UNITED STATES PATENT AND TRADEMARK OFFICE

10/629,882 07/28/2003 John C. Devine MER103 5575

Office Action Summary	Application No.		Applicant(s)	
	10/629,882		DEVINE, JOHN C.	
	Examiner		Art Unit	
	Nguyen N. Hanh		2834

DETAILED ACTION

FIG. 4

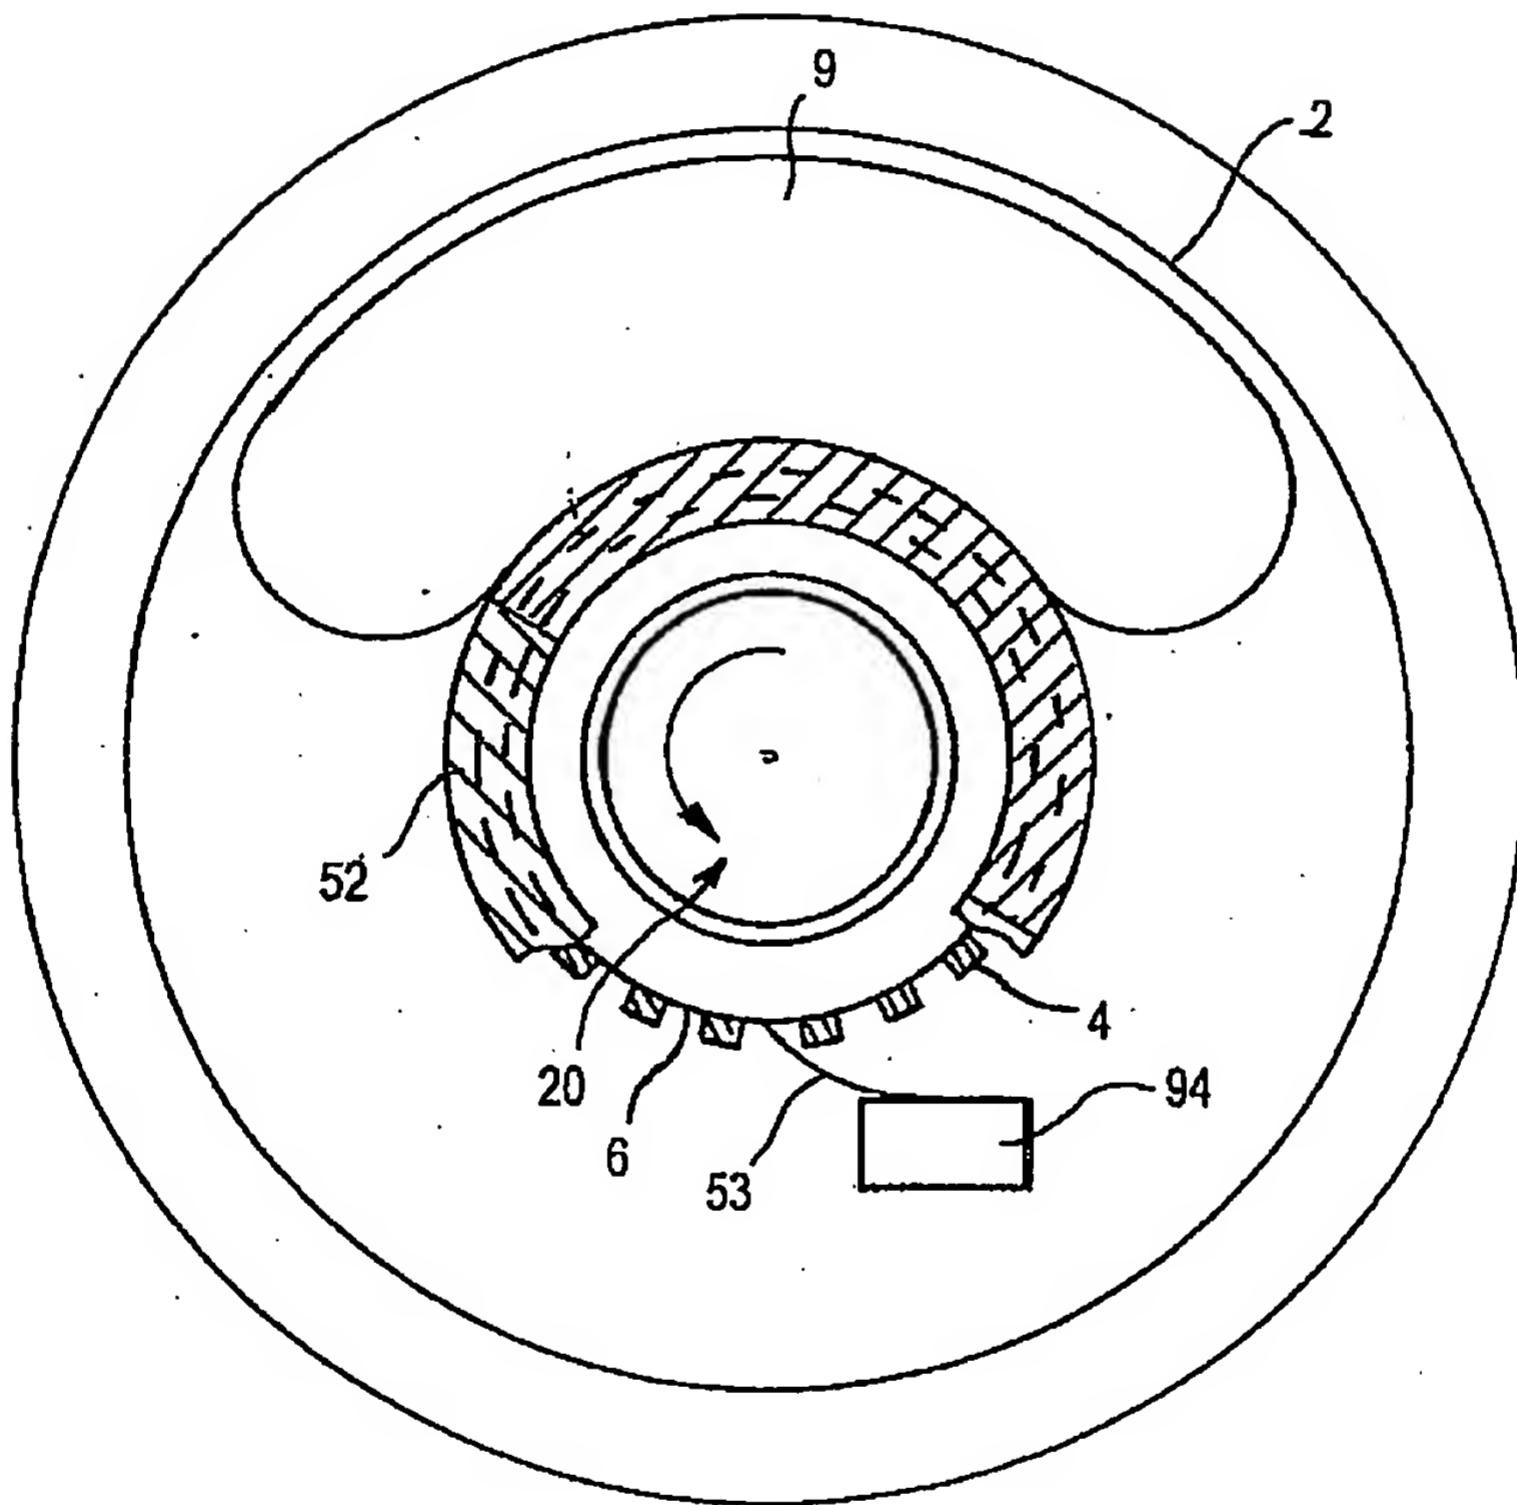
Not approved by
Examiner.

HNN
1/29/07
